**WESTREC MARINA MANAGEMENT, INC.
ON BEHALF OF THE CHICAGO PARK DISTRICT**

**INVITATION FOR BID (IFB)
FOR
DELIVERY OF FLOATING DOCKS AT BURNHAM HARBOR**

W-20002

Addendum 1

DRAWN BY: B.R.S.	FILE NAME: 5299B-1
CHECKED BY: ADAMS	JOB # 971430
PLOT AT: 1" = 50'-0"	DATE: 6-11-97
	PLAN # 5299B
	SHEET 1 OF 24

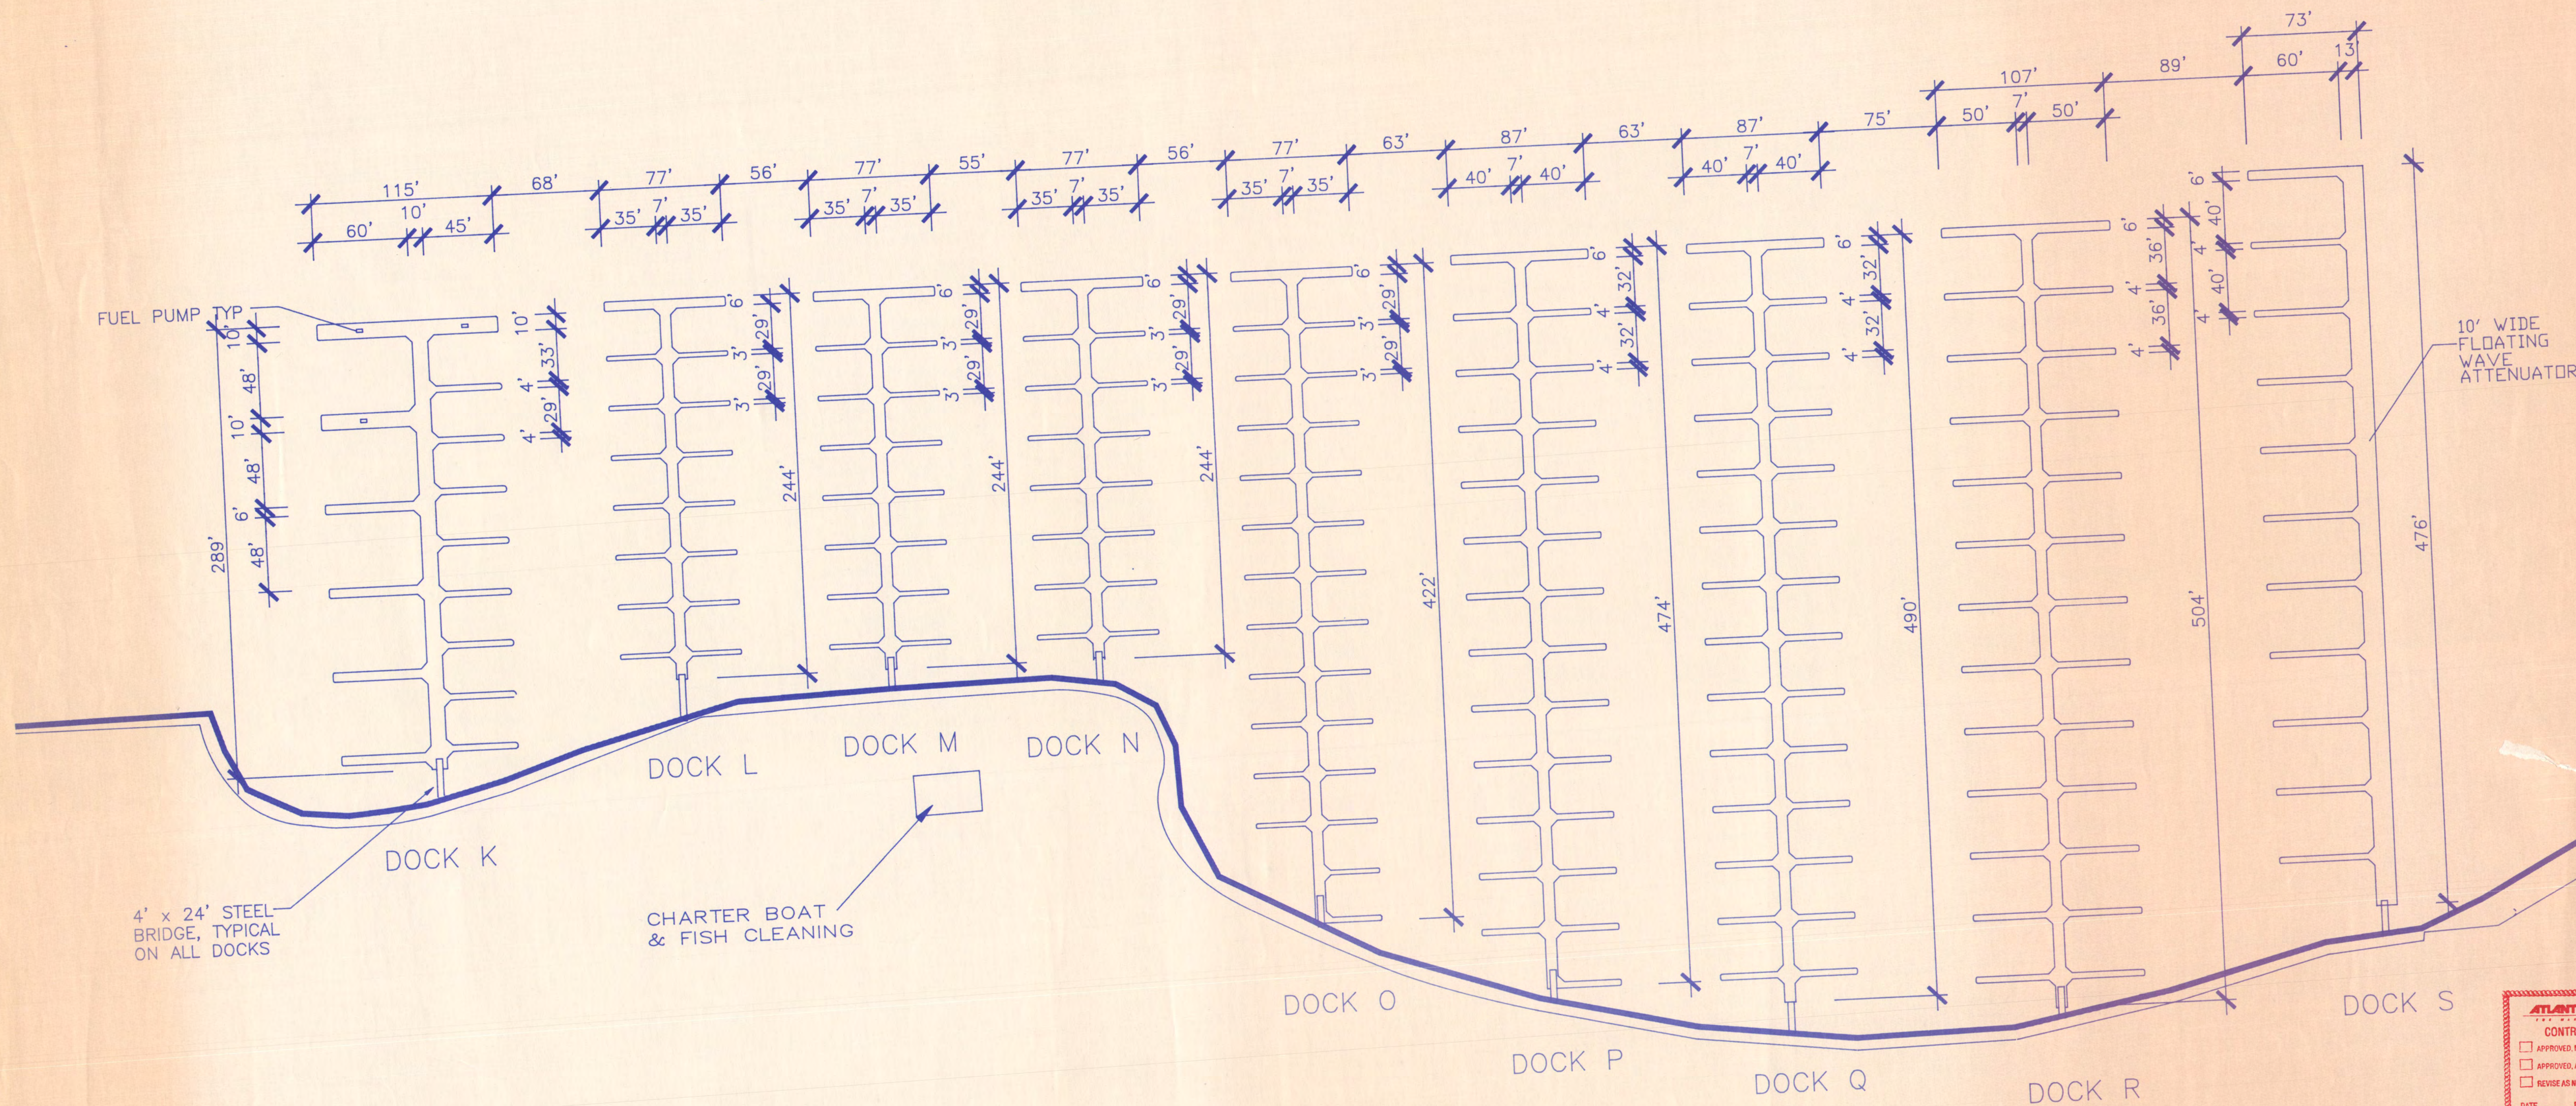
- Q.** Are they the correct specifications for Burnham Harbor given the project, 2010 date and 31st street harbor location with the use of Southern Yellow Pine decking?
- A.** No. Please price this with Wear Deck composite decking.
- Q.** Docks M, N and O layouts are very close to the existing. Will the stake pile chain be floated when the existing docks are removed, and can we reuse them for the new docks?
- A.** The current M, N, and O docks are not anchored with pile and chain but are secured by pilings. However, in your anchoring plan you can propose using the existing piles to anchor the new docks. In 2019, Docks P and Q were replaced and some of the piles were cut and used to anchor the new chain docks.
- Q.** Can you send me the existing stake pile layout for docks M, N and O
- A.** See attached drawings.
